1958 Agreement:**Consideration of draft amendments to existing****UN Regulations submitted by GRVA****Proposal for Supplement 3 to the original version of UN
Regulation No. 152 (AEBS for M₁ and N₁)****Submitted by the Working Party on Automated/Autonomous and
Connected Vehicles ***

The text reproduced below was adopted by the Working Party on Automated/Autonomous and Connected Vehicles (GRVA) at its seventh session in September 2020 (ECE/TRANS/WP.29/GRVA/7, para. 54). It is based on ECE/TRANS/WP.29/GRVA/2020/26. It is submitted to the World Forum for Harmonization of Vehicle Regulations (WP.29) and to the Administrative Committee (AC.1) for consideration at their March 2021 sessions.

Figure 1

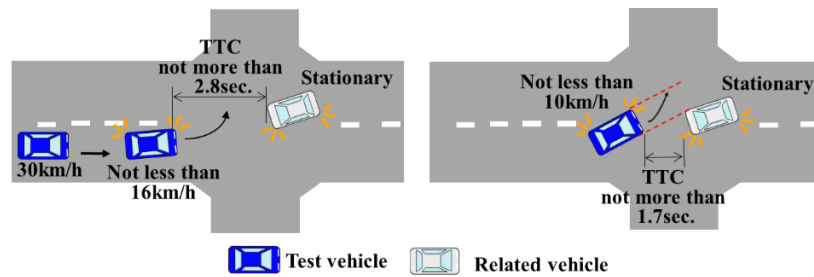
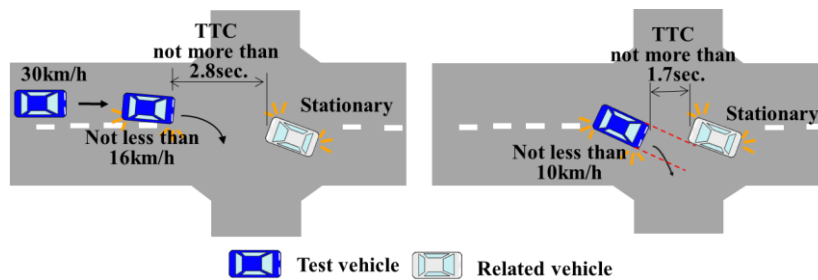
Insert new Scenarios 1 to 4, to read:

Left turn or Right turn at the intersection

- 1.1. In this scenario, the subject vehicle passes by a left turn or right turn in front of an oncoming vehicle that is stopped to make a left turn or right turn at an intersection.

The subject vehicle drives at a speed of 30 km/h (with a tolerance of +0/-2 km/h) toward the intersection, and decelerates by braking to a speed of not less than 16 km/h at a point where the subject vehicle begins to steer left / right, and the Time To Collision (TTC) to the oncoming vehicle is not more than 2.8 seconds. When the subject vehicle turns left or right in the intersection, the speed is reduced to not less than 10 km/h, and then drives at a constant speed. The TTC to the oncoming vehicle is not more than 1.7 seconds at when the overlap ratio between the subject vehicle and the oncoming vehicle becomes 0 per cent.

Figure 2

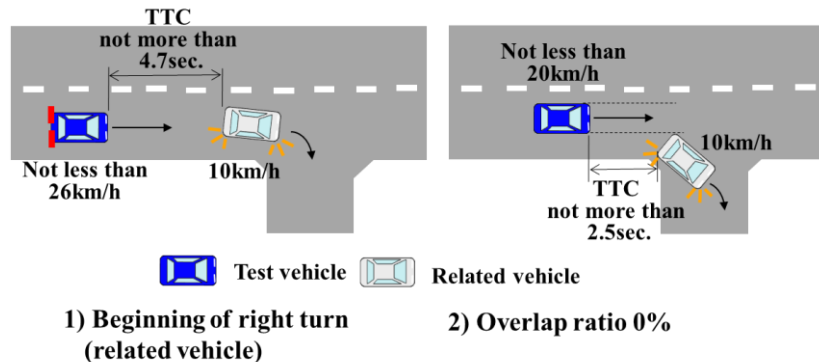
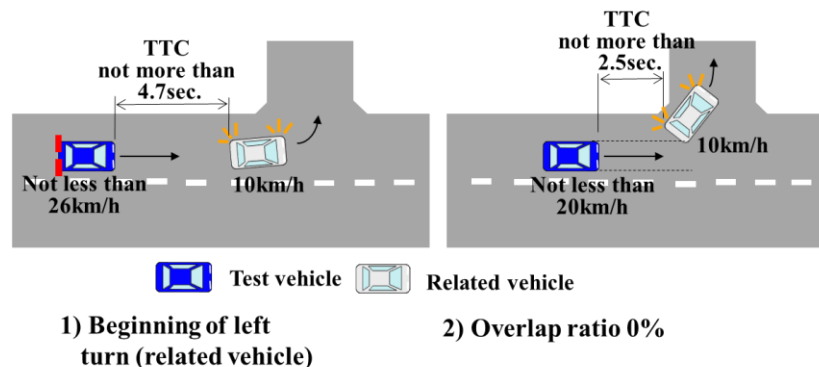
Scenario 2**Right turn or Left turn of a forward vehicle**

- 2.1. In this scenario, the subject vehicle follows a forward vehicle. After that, the forward vehicle turns right or left at a corner, and the subject vehicle goes straight.
- 2.2. An example of the detail scenario:

Both the forward vehicle and the subject vehicle drive at a speed of 40 km/h (with a tolerance of +0/-2 km/h) on the straight road. The forward vehicle decelerates by braking to a speed of 10 km/h (with a tolerance of +0/-2 km/h) in order to turn right or left at the corner, and the subject vehicle also decelerates by braking to keep appropriate distance with the forward vehicle. At when the forward vehicle begins to turn right or left, the speed of the subject vehicle is not less than 26 km/h and the TTC to the frontal vehicle is not more than 4.7 seconds. After that, the subject vehicle decelerates to a speed of not less than 20 km/h, and then drives at a constant speed. The TTC to the forward vehicle is not more than 2.5 seconds at when the overlap ratio between the subject vehicle and the forward vehicle becomes 0 per cent.

Figure 3
Curved road with guard pipes and a stationary object

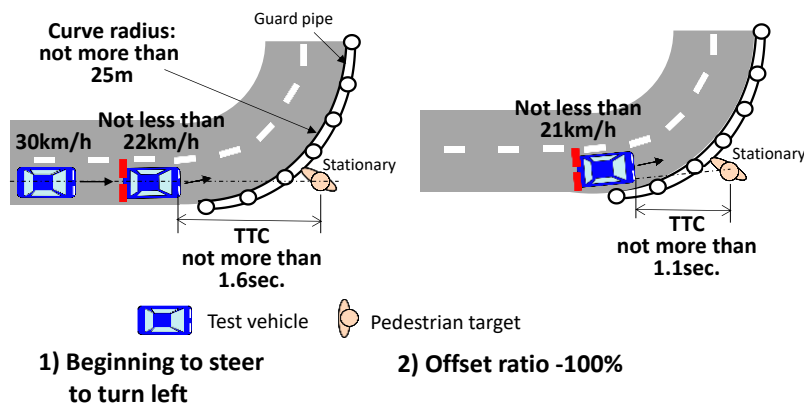
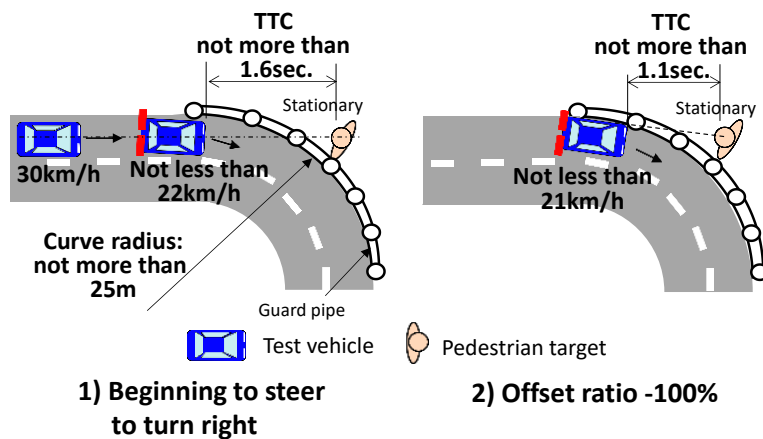
**Scenario 3****Curved road with guard pipes and a stationary object**

- 3.1. In this scenario, the subject vehicle drives a small radius curved road of which the guard pipes are constructed to the outer side, and a stationary vehicle (M_1 category), a stationary pedestrian target or a stationary bicycle target is positioned just outside of the guard pipes and where on the extension of the centre of the lane.
- 3.2. An example of the detail scenario:

The subject vehicle drives at a speed of 30 (with a tolerance of ± 2 km/h) km/h toward the curve of which the radius is not more than 25 m at the outer side of the road, and decelerates by braking to a speed of not less than 22 km/h at a point where the subject vehicle enters the curve. The TTC to the stationary object is not more than 1.6 seconds at when the subject vehicle begins to turn in the curve. In the curve, the subject vehicle drives outer lane than the centre of the road. After that, the subject vehicle continue to turn in the curve at a constant speed of not less than 21 km/h. The TTC to the stationary object is not more than 1.1 second at when the overlap ratio between the subject vehicle and the stationary vehicle becomes 0 %, or at when the offset ratio between the subject vehicle and the centre of the stationary pedestrian target or the stationary bicycle target becomes -100 per cent.

Figure 4
Lane change due to road construction

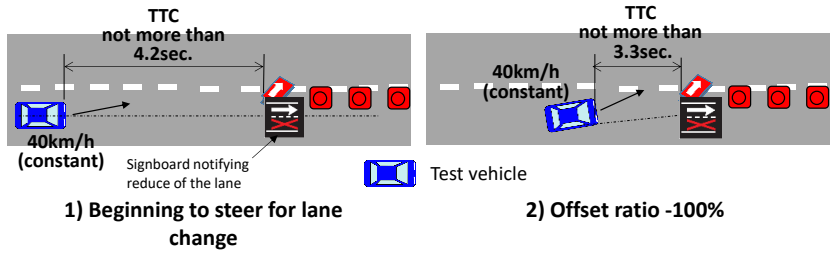
Lane change due to road construction

- 4.1. In this scenario, the subject vehicle changes the lane in front of the signboard which is positioned in the centre of the lane and notifies the driver that the lane is reduced.
- 4.2. An example of the detail scenario:

The subject vehicle drives a straight road at a speed of 40 km/h (with a tolerance of ± 2 km/h), and begins to steer in order to change the lane in front of the signboard which notifies reducing the lane. No other vehicles approach the subject vehicle. The TTC to the signboard is not more than 4.2 seconds at when the subject vehicle begins to steer. During changing the lane, the speed of the subject vehicle is constant, and the TTC to the signboard is not more than 3.3 seconds at when the offset ratio between the subject vehicle and the centre of the signboard becomes -100 per cent.
